**TECHNICAL MEMORANDUM NO. 1
SUPPLEMENTAL BASIS OF DESIGN - RESPONSE TO ECRB COMMENTS**

SUBJECT: Terminal 1, Latitude Project – Response to ECRB Comments

Reference: ENGEO; Existing Geotechnical Conditions and Seismic Slope Stability, Terminal One, Richmond, California; July 24, 2017; Project No. 5931.000.000

Project			Terminal One - Section 4-4'		
Scale	1:1500	Author	T. Bradford	Project No.	
Date	9/29/2017	Condition	Pseudo-Static		5931.000.000

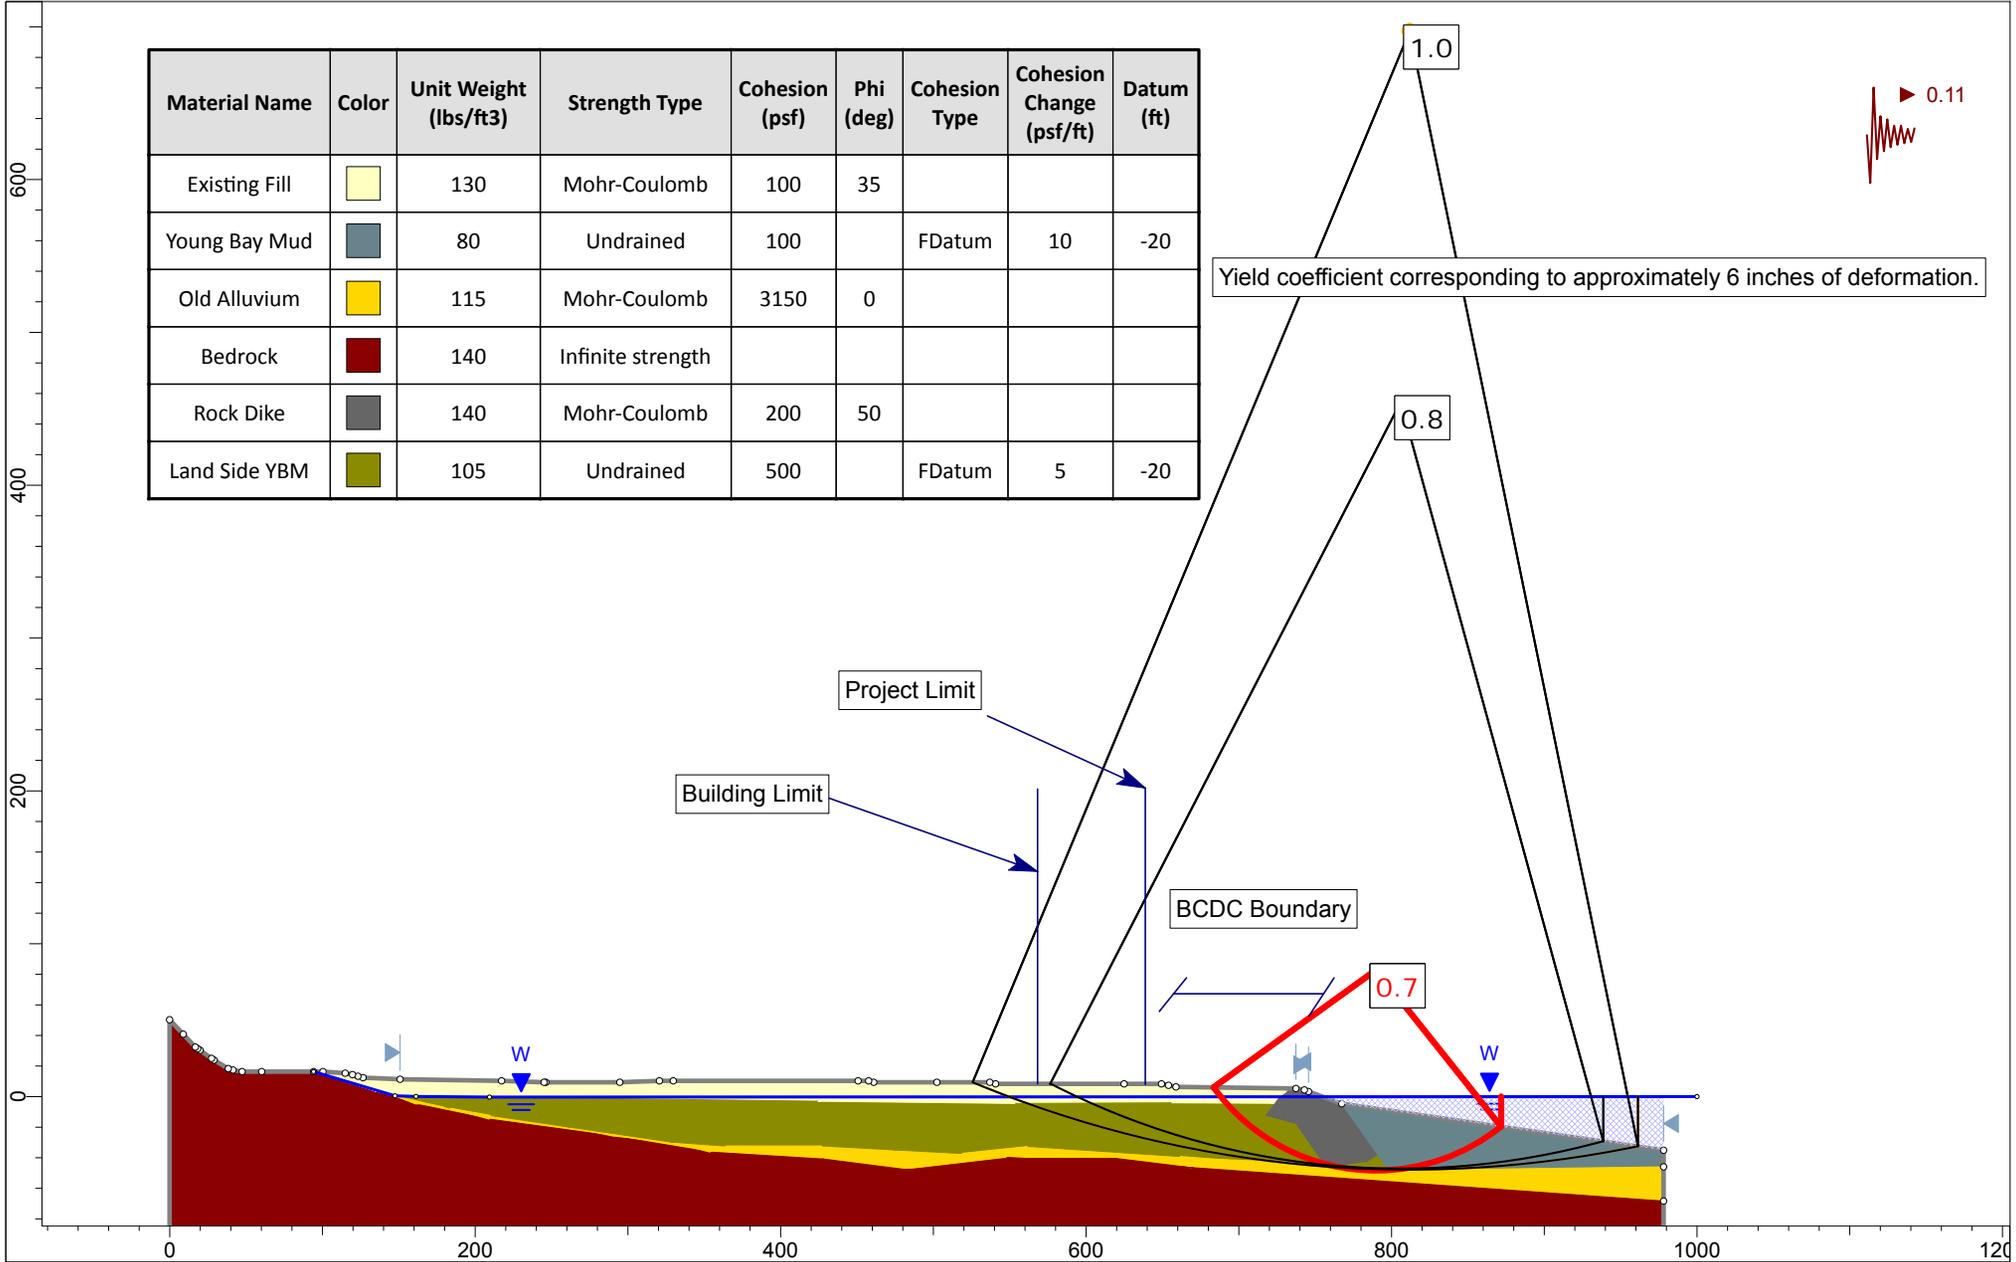
ECRB Comment #5:

Provide information gathered regarding subsurface profiles in other parts of the site, including longitudinally.

Section 4-4', following Figure 3, illustrates a cross-section east of the limits of the proposed DSM. In this area, the buildings are set back 185 feet from the shoreline. Using the same slope stability and deformation analysis we used in Reference 1, and outlined in NCHRP 611, we determined that the yield coefficient for a critical failure surface extending back through the project boundary and into the proposed structural area corresponds with a deformation of 6 inches or less. As discussed in the California Geological Survey's "Guidelines for Evaluating and Mitigating Seismic Hazards in California", Special Publication 117A, dated 2008, displacements less than 6 inches, "are unlikely to correspond to serious landslide movement and damage." We recommend in this area of the project that the building be designed considering this potential 6 inches of lateral ground deformation and associated stretch of the building. Between the building area and the shoreline, the displacement will be incrementally larger closer to the water. The majority of potential displacement would occur within the parking lot of the adjacent marina off the project limits.

Project			Terminal One - Section 2-2'		
Scale	1:600	Author	T. Bradford	Project No.	
Date	October 4, 2017	Condition	Wedge-Type Failure

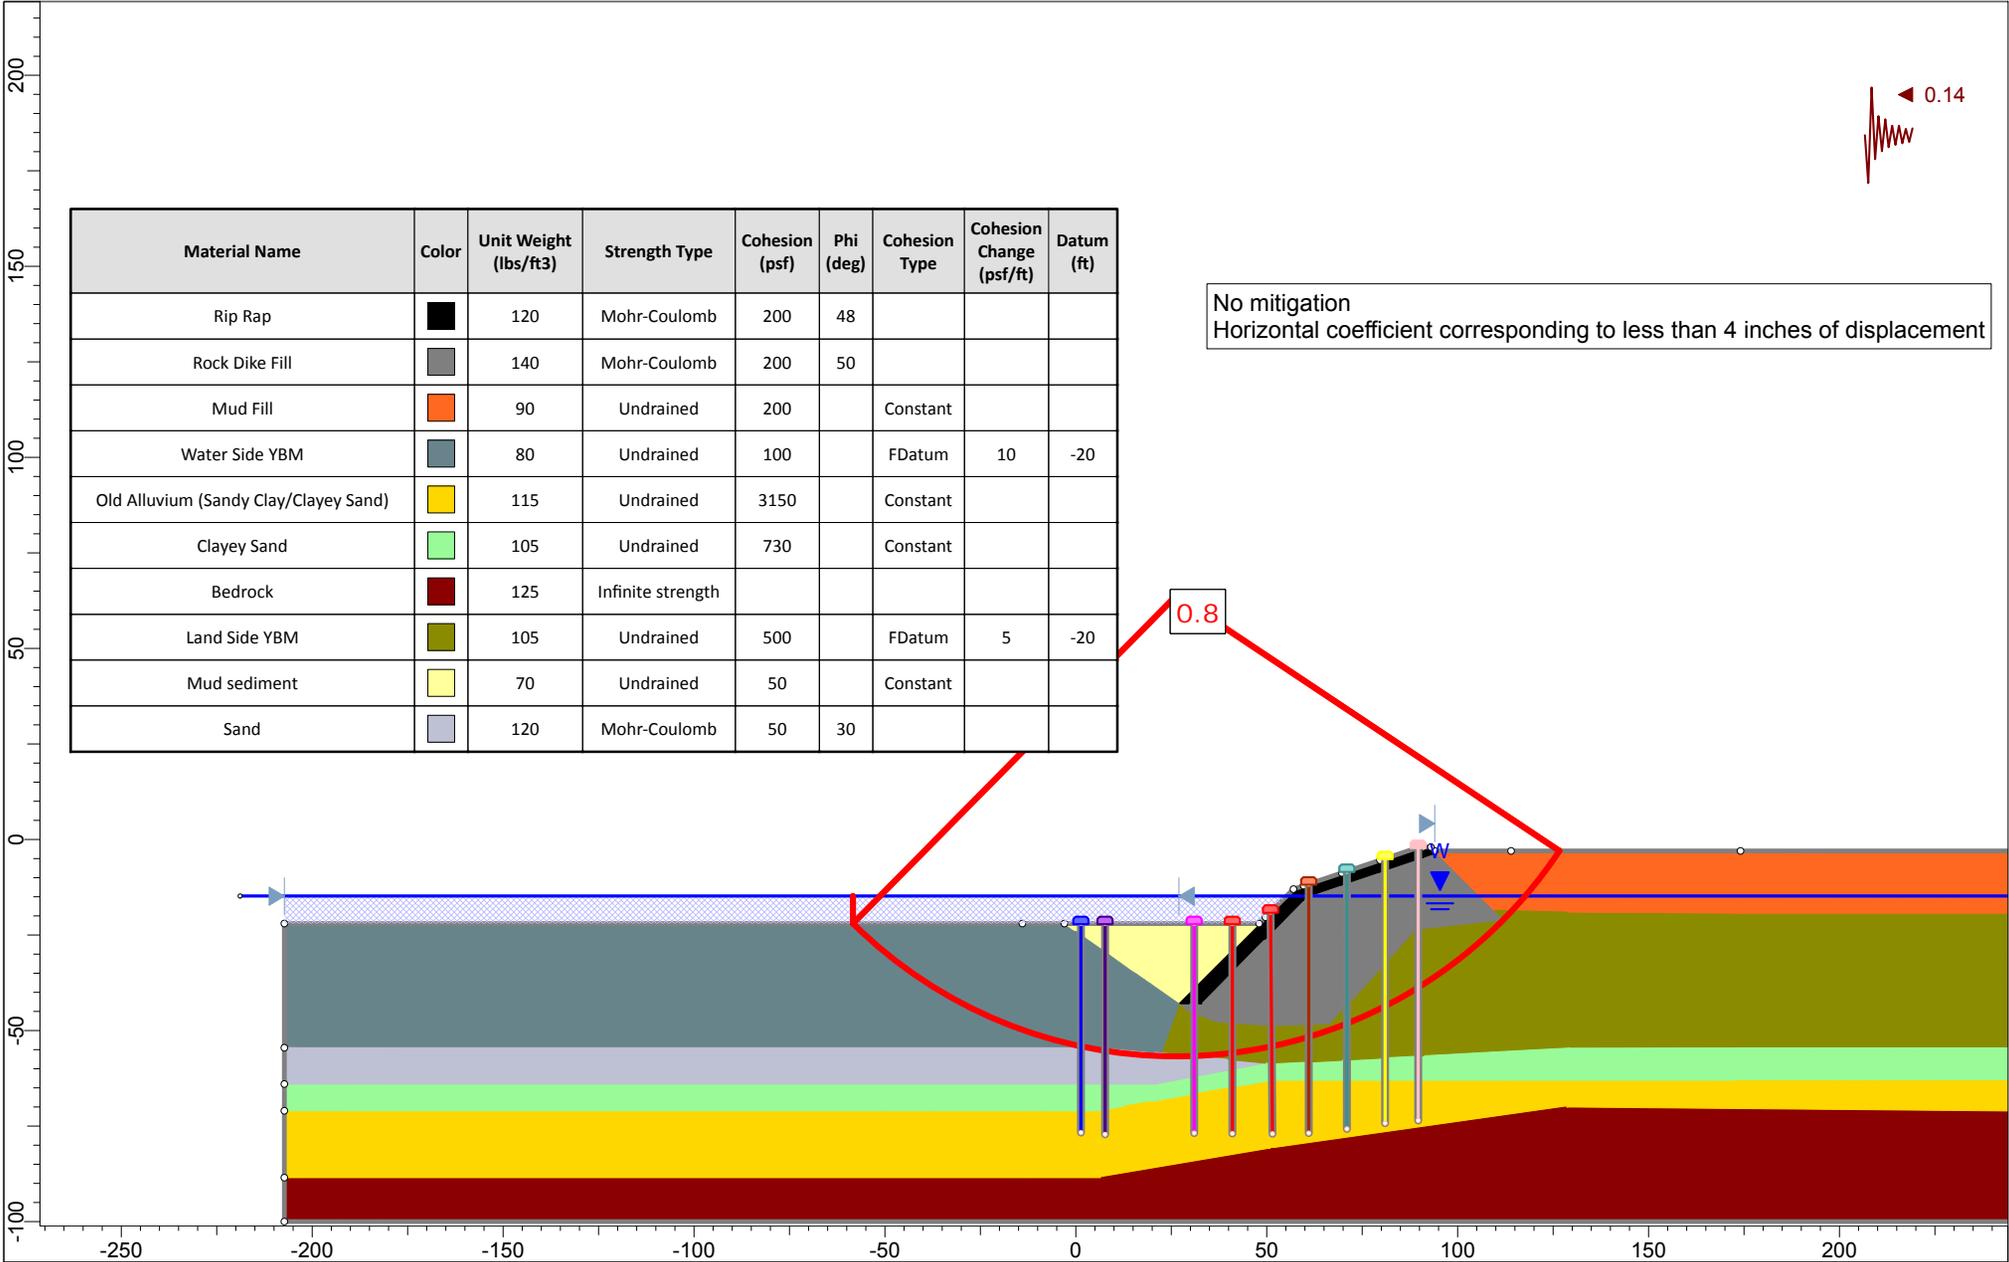
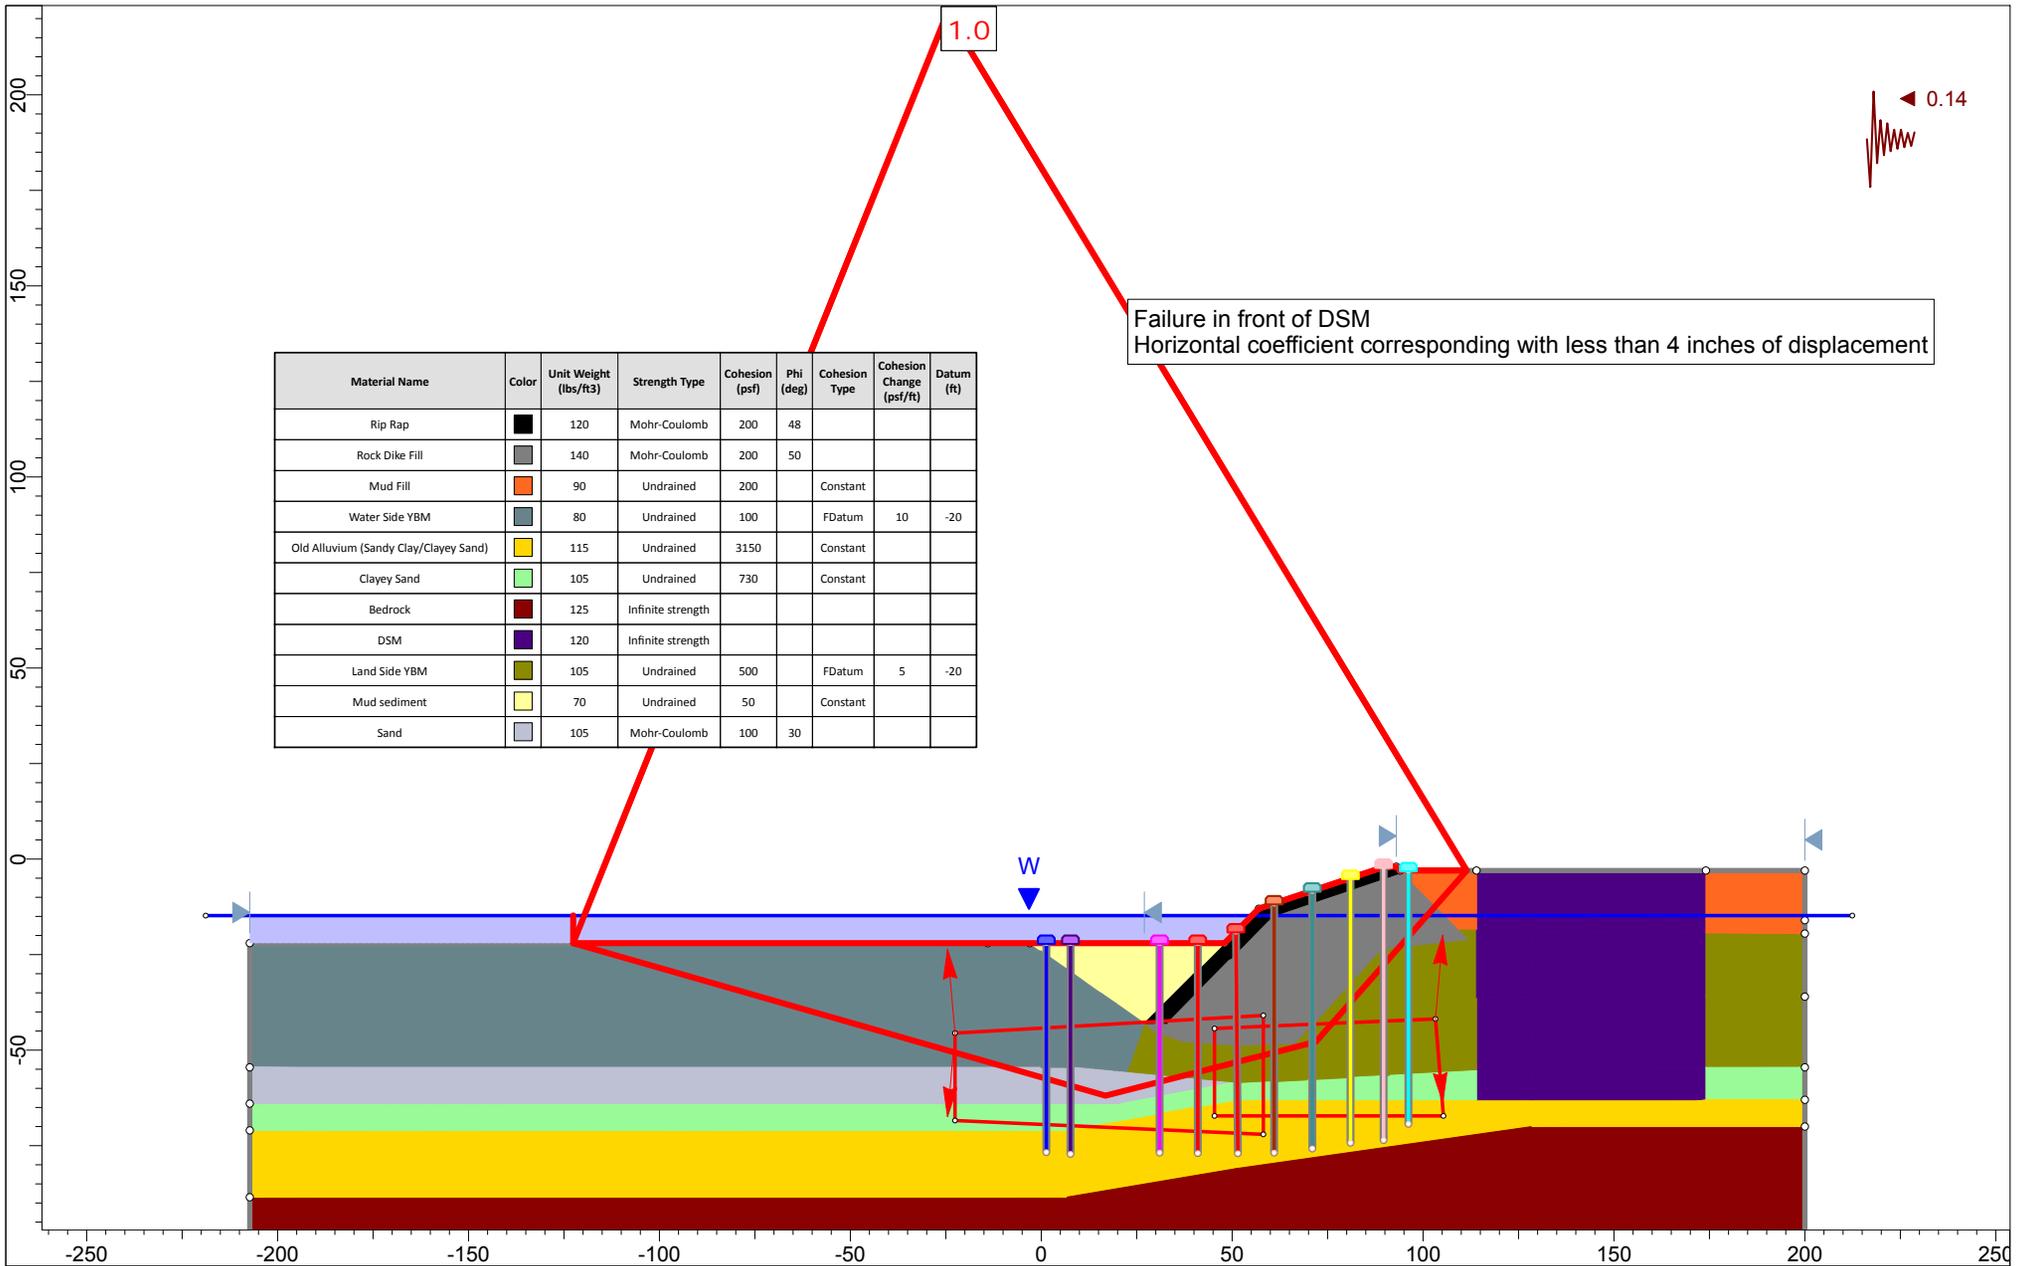
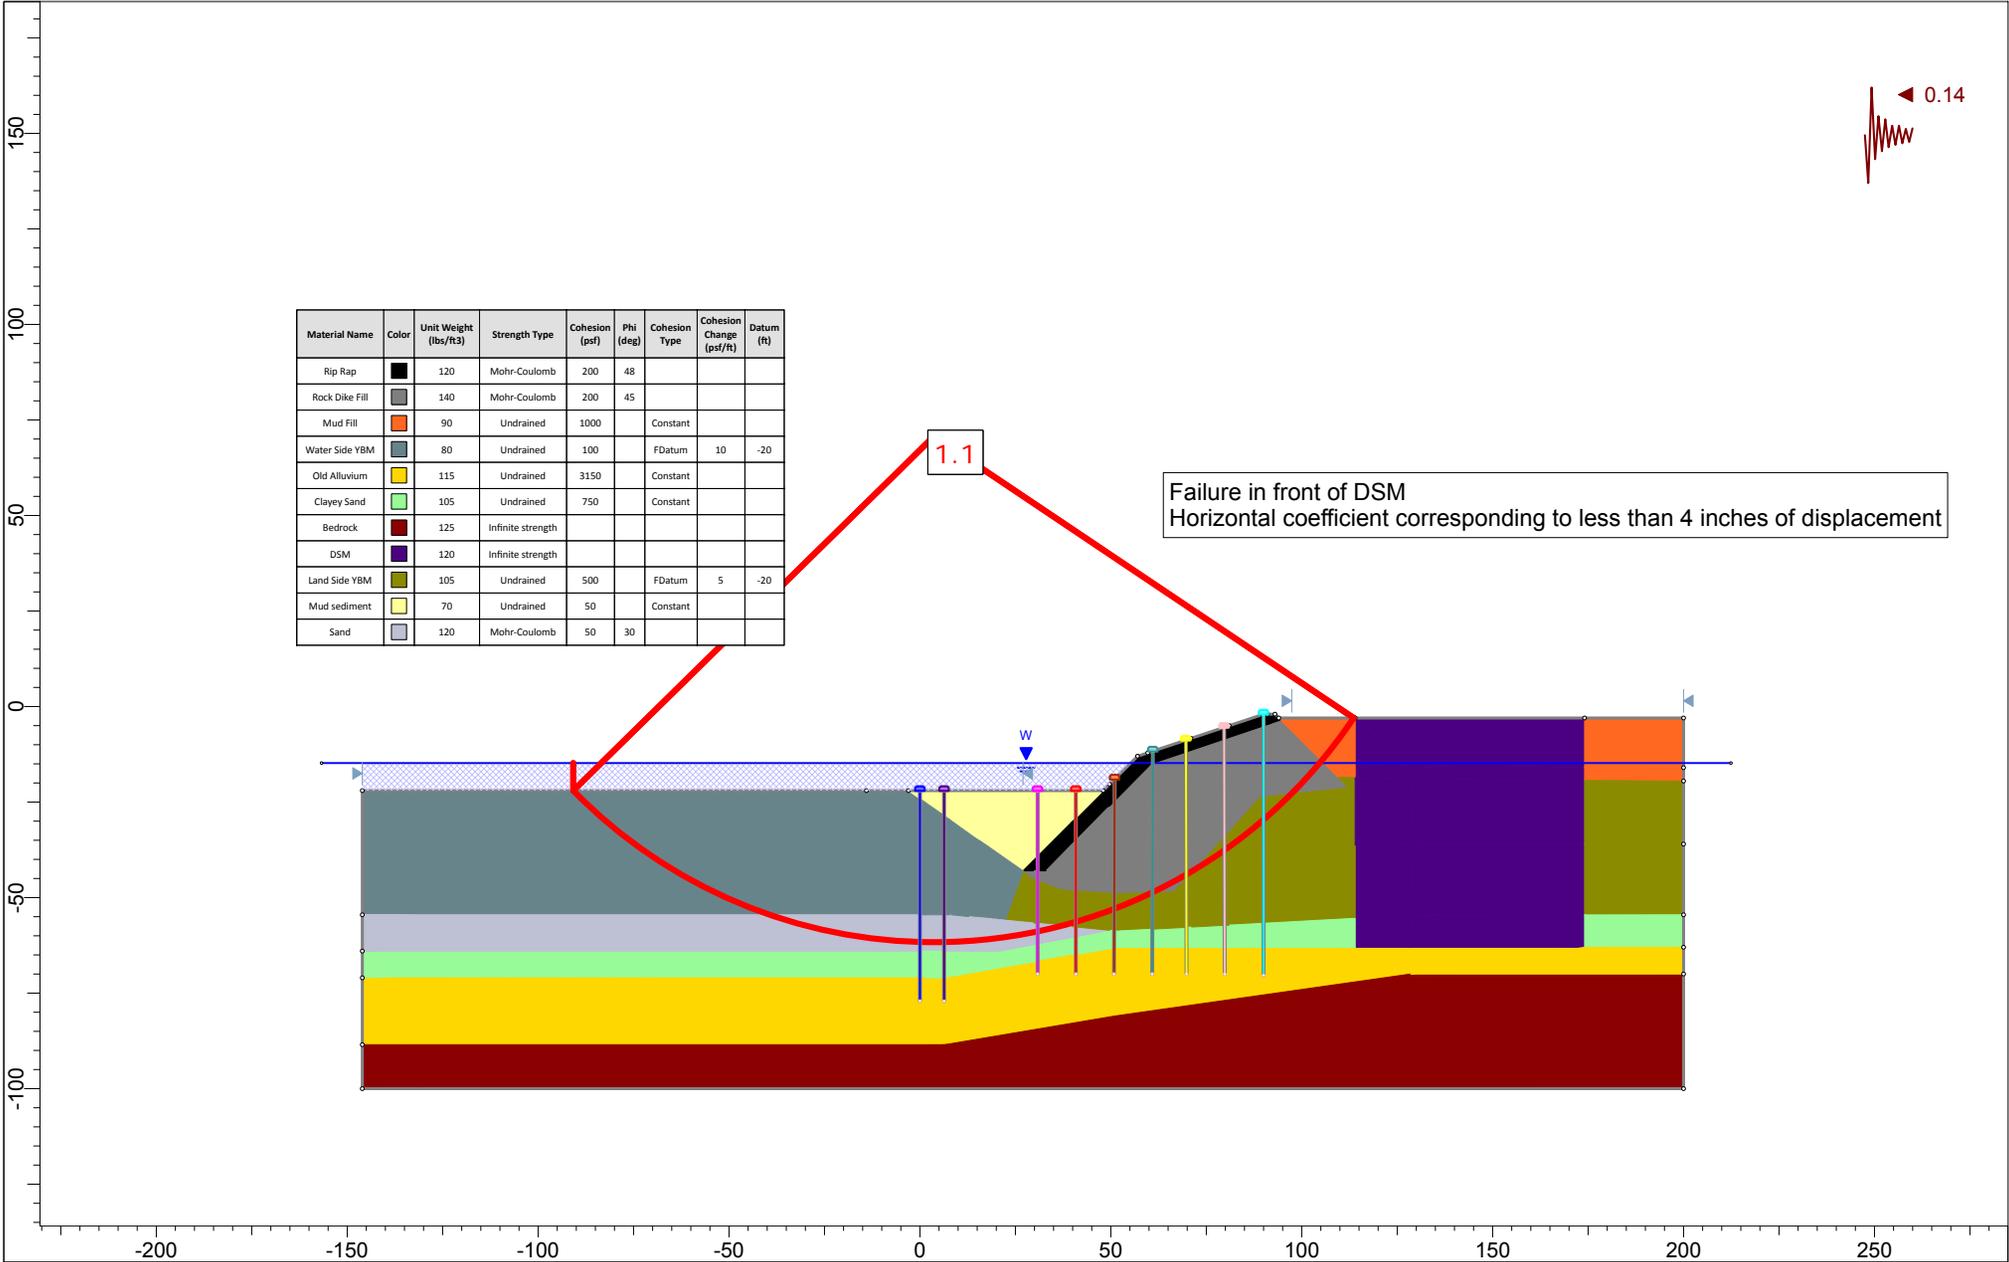
ECRB Comment #3:

Reexamine the deflections for the piles during an event and the configuration and depth of the DSM buttress.

Based on input from the ECRB Board as discussed in our Response #2 above, we revisited and revised our interpreted soil profile for the slope stability analysis of the wharf and shoreline. The presumed potentially liquefiable layer now extends beneath the wharf structure (Figure 3). We present the results of the analysis in Attachment A, which still achieve satisfactory performance based on the analysis criteria outlined in Reference 1.
